SUBJECT: Forwards addl info in response to IE Bulletin 85-003,
 "Motor-Operated Valve Common Mode Failures During Plant
 Transients Due to Improper Switch Settings," per 870917
 commitment.

Subject: Oconee Nuclear Station
Docket Nos. 50-269, -270, -287

Response To The NRC Request For
Additional Information Concerning
Oconee's Responses To IE Bulletin 85-03
Dated September 17, 1987

FLOW DIAGRAM OF
EMERGENCY FEEDWATER SYSTEM
OCONEE NUCLEAR STATION
FIGURE 10.4-13

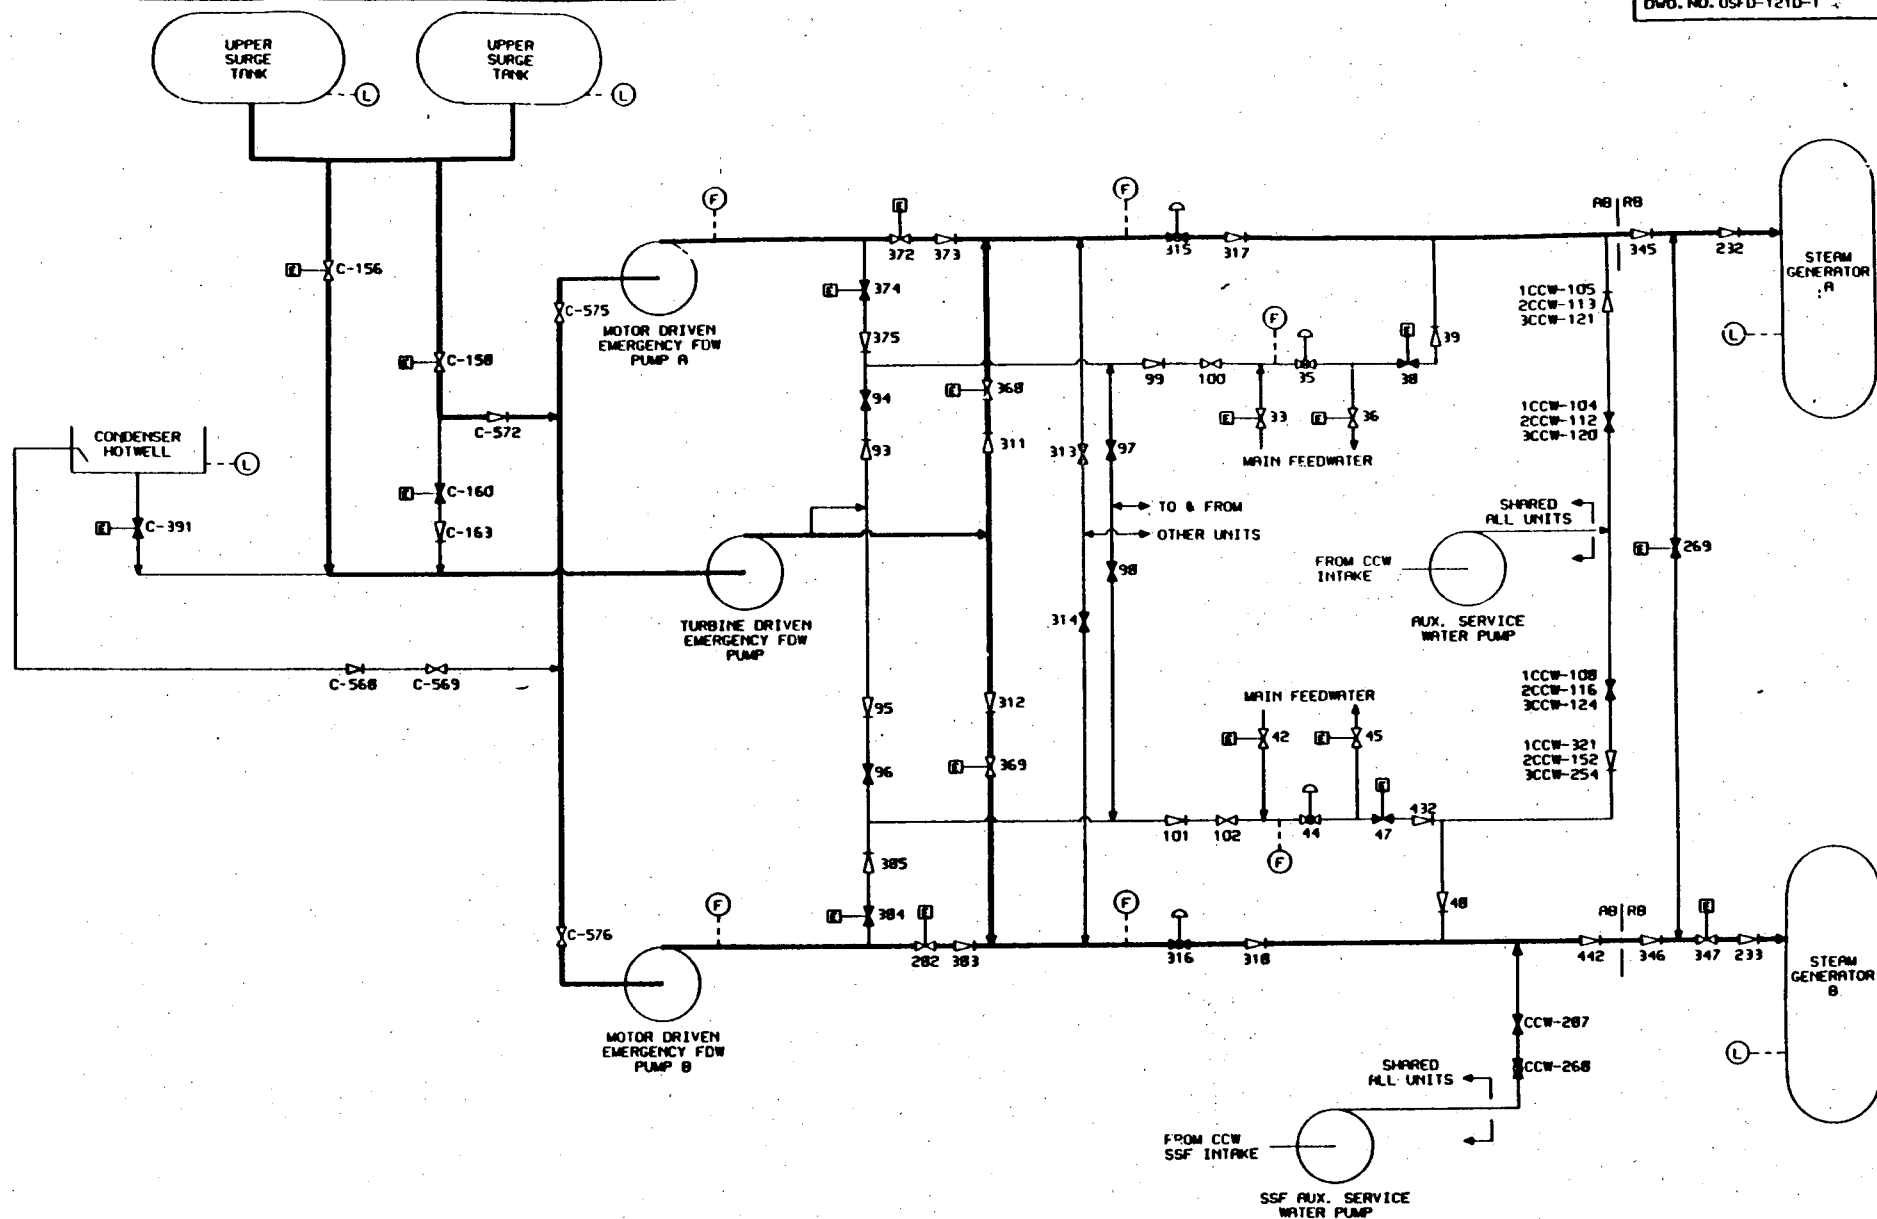
Please explain on an individual basis why the 12 MOVs shown in discharge lines of the EFW pumps on FSAR Figure 10.4-13 for Oconee 1 are not listed in the response of 05-16-86. Assume inadvertent equipment operations as required by Action Item a of the bulletin, and consider the separation of EFW and normal FW Systems. As appropriate, revise the response of 05-16-86 to include these valves. This comment applies also to units 2 and 3.

We have been unable to locate MOV 1-FDW-347, which is identified in the response of 05-16-86. However, we are able to find MOV 1-FDW-47 on FSAR Figure 10.4-13, in a discharge line to Steam Generator 1B. Is this valve meant? This question applies in essence to units 2 and 3 also.

FDW 382 (misabeled as FDW 282 on FSAR Figure 10.4-13)- 'B' MDEFWP discharge to line 'B2':

FDW 347 is the second valve upstream from the 'B' S/G and is shown on the 1986 update of FSAR Figure 10.4-13. This valve is a standby shutdown facility valve and is included in the Oconee IWV program for surveillance testing. Inadvertent closure and failure of this MOV would prevent emergency FDW from being supplied to the 'B' S/G via the emergency FDW header.
